Access Compliance Report

Public Rights-of-Way (Curb Ramps)

Intersection ID: 2928	Main Street: PROSPERITY_CHURCH_RD	Cross Street: RIDGE_RD	Location: NW
ADA ID: CD2824373F98	Ramp Type: Perp	Initial Pass/Fail: Fail	Overall Compliance: No
		Severity Score: 12.5

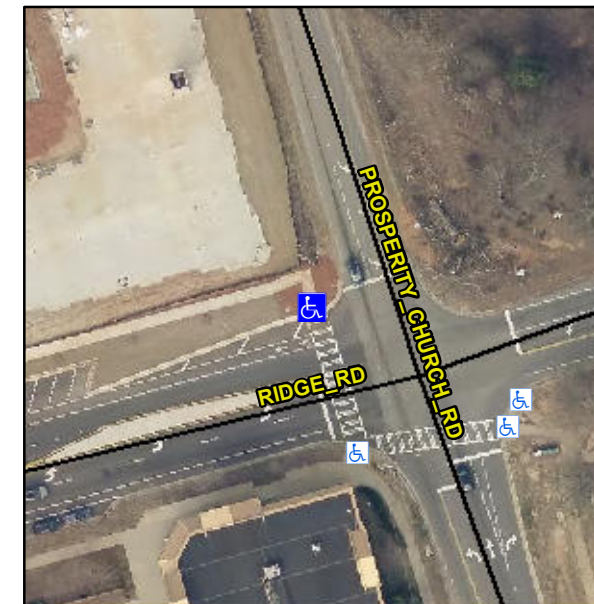
R304.2.2

Compliance	Description	Data	Compliance	Description	Data
N/A	Ramp Length (in)	96.0	No	Ramp Slope (%)	11.2
Yes	Ramp Width (in)	71.0	Yes	Ramp XSlope (%)	0.9
N/A	Flare Type LT	N/A	N/A	Flare Type RT	N/A
N/A	Flare Slope LT (%)	N/A	N/A	Flare Slope RT (%)	N/A
N/A	Flare Traversable LT?	N/A	N/A	Flare Traversable RT?	N/A
N/A	Landing Length (in)	N/A	N/A	DWS Provided?	N/A
N/A	Landing Width (in)	N/A	N/A	DWS Contrast?	N/A
N/A	Landing Slope (%)	N/A	N/A	DWS Length (in)	N/A
N/A	Landing X Slope (%)	N/A	N/A	DWS Full Width?	N/A
N/A	Landing Curb? (Y/N)	N/A	N/A	DWS Offset (in)	N/A
N/A	Shared Landing?	N/A			
N/A	Gutter Ponding?	N/A	N/A	Gutter Slope (%)	N/A
N/A	Gutter Lip Ht (in)	N/A	N/A	Gutter X Slope (%)	N/A
N/A	Painted X Walk1?	Yes	N/A	Painted X Walk2?	N/A
	X Walk 1 Direction	To S		X Walk 2 Direction	N/A
N/A	X Walk 1 Width (in)	118.0	N/A	X Walk 2 Width (in)	N/A
	X Walk 1 Slope (%)	0.4		X Walk 2 Slope (%)	N/A
	X Walk 1 X Slope (%)	0.5		X Walk 2 X Slope (%)	N/A

Remove & Replace Entire Ramp.
